**GREATER TEXOMA UTILITY AUTHORITY
BOARD MEETING
FEBRUARY 20, 2023**

CONSIDER AND ACT UPON KIEWIT WATER FACILITIES SOUTH COMPANY'S GUARANTEED MAXIMUM J – ARCHITECTURAL AND POTENTIAL CHANGE ORDERS IMPACTING EARLY WORKS GMP PACKAGES FOR CITY OF SHERMAN'S SOUTH WASTEWATER TREATMENT PLANT – MBR PROJECT.

Re: COSK South Wastewater Treatment Plant - MBR Project
Amendment 06 Recommendation

South Wastewater Treatment Plant – MBR Project

Figure 1: 65% Cost Model Blower Building

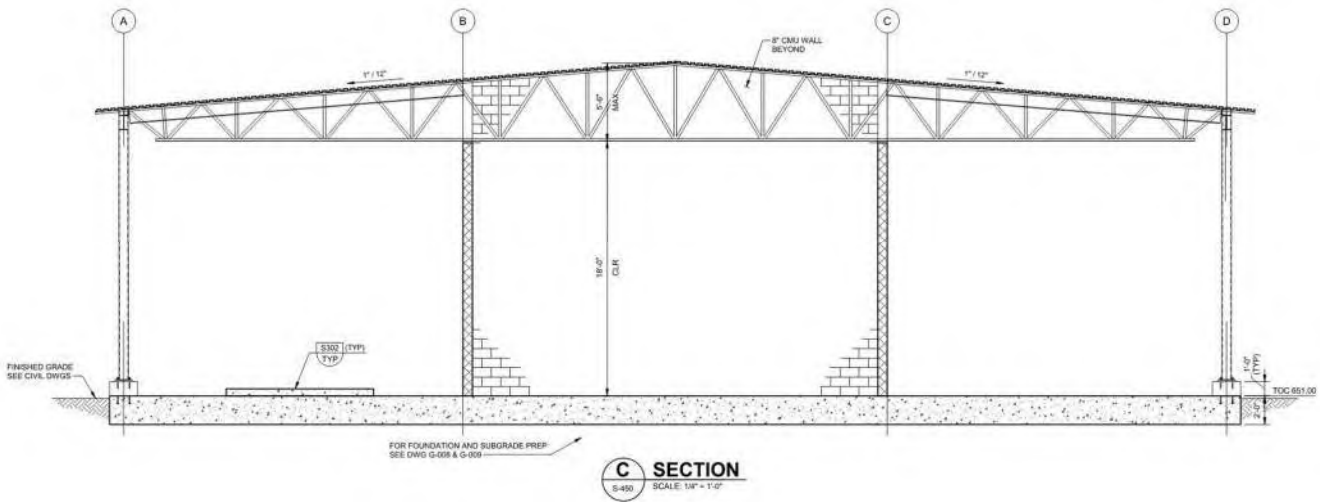
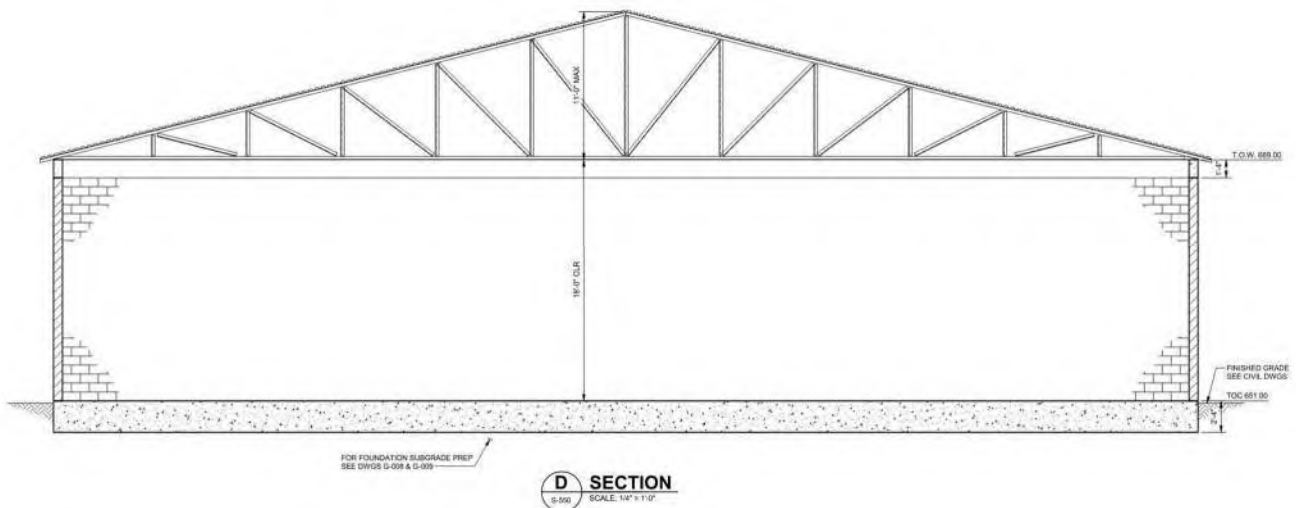
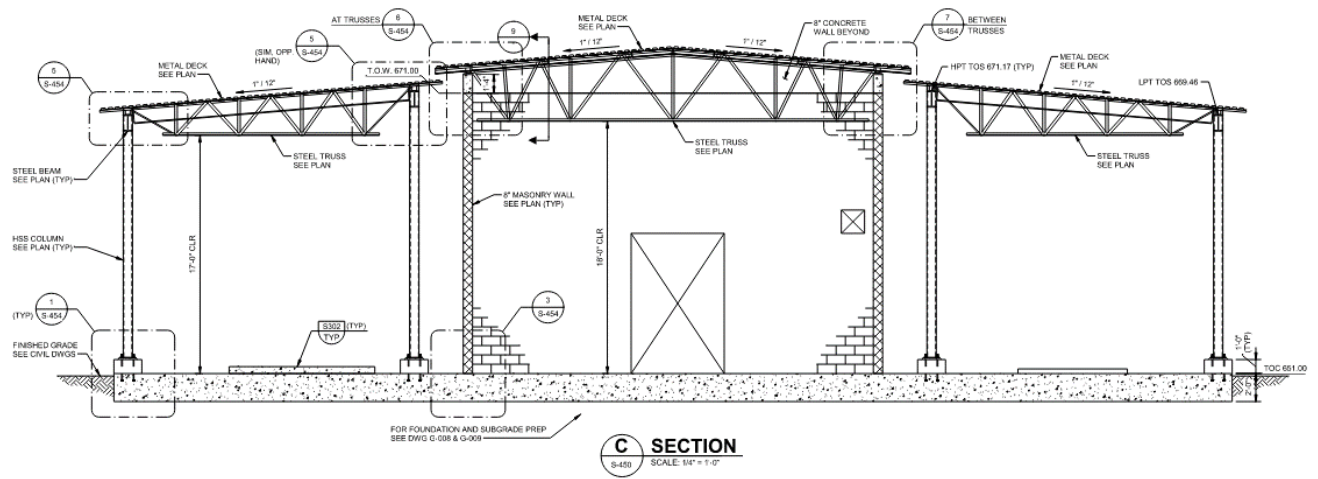
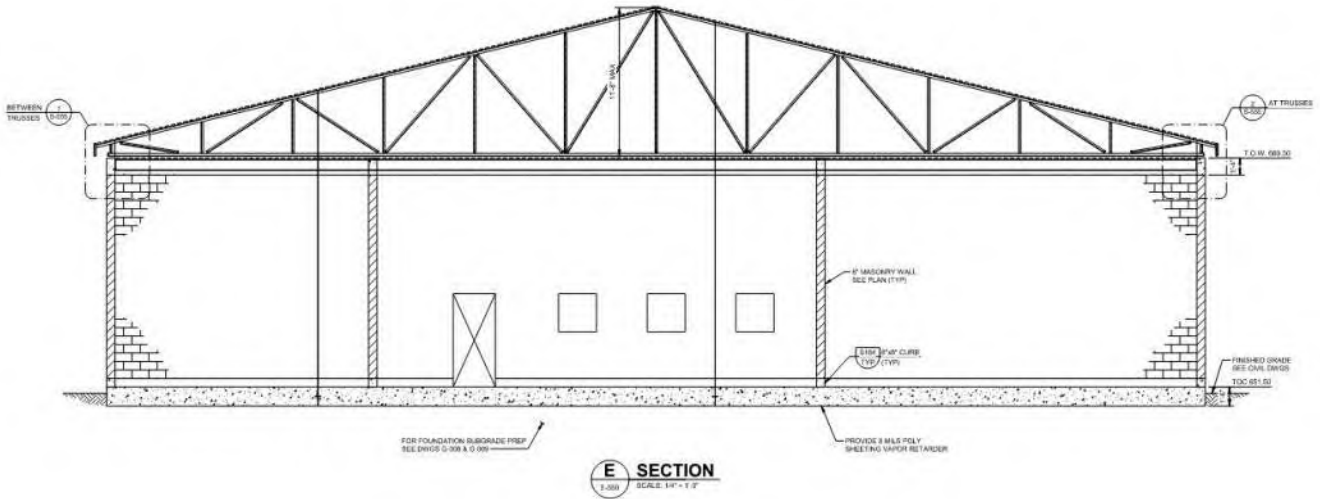
The cost for the proposed GMPJ as presented in the 65% Design Cost Model has changed. Revised Drawings were issued with BP09-001, with the following impacts to costs:

1. In the 30% and 65% Cost Model HVAC and Plumbing were included in GMPI Process Mechanical for a total cost of \$800,000. These costs were included in this Bid Package.
2. At the Blower Building, six (6) Steel Columns were added for roof support.
3. At the Blower Building, structural steel W-beams were increased from W12x35 to W14x53. Additional rows of W-beams were added at the Steel Columns noted above.
4. At the Blower Building, structural steel C-Channels (C5x9) were added at both ends of the building to support the roof.
5. At the Blower Building, a CMU wall was replaced by a Concrete wall above the top line of the CMU.
6. At the Blower Building, a concrete beam is now shown on top of the CMU for connection to the Trusses.
7. At the Membrane Support Building, CMU walls were added for the Control Room, Rest Room and Office.

8. At the Membrane Support Building, structural steel W-beams (W10x22) were added for the Control Room, Rest Room and Office.
9. At the Membrane Support Building, structural steel C-Channels (C5x9) were added at both ends of the building to support the roof.
10. At the Membrane Support Building, an 8"x8" curb was added at the base of the CMU walls.
11. At the Membrane Support Building, a Concrete wall above the top line of the CMU was added.
